SCA100

Design Enhancement

Scania: 4 series

Equivalent to 1386686, 1402272

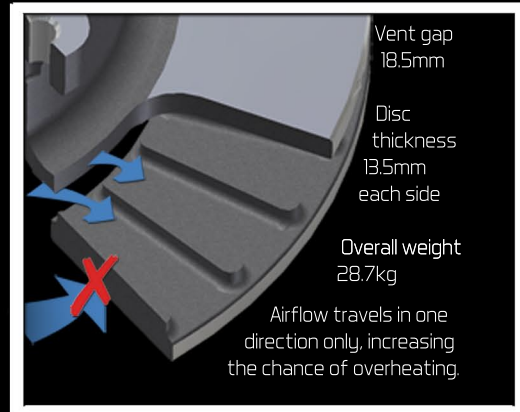
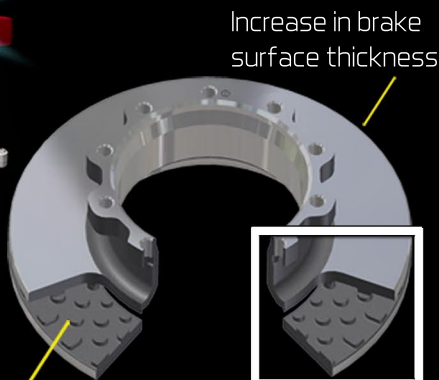
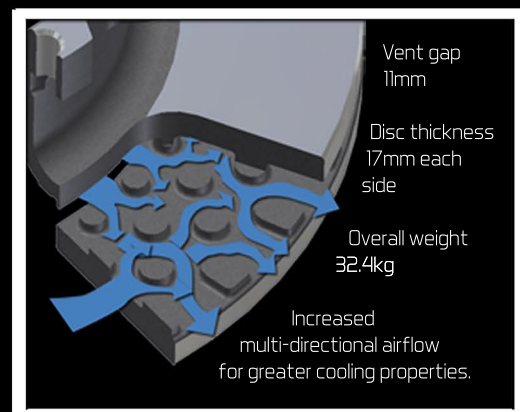
Original Design

Wall type vent

Juratek Design

Pillar vent design creating
significantly more airflow.

✓ This new design improves the airflow and heat distribution due to the change in vent design and increased thickness of the braking surface, making the disc less likely to crack under severe conditions
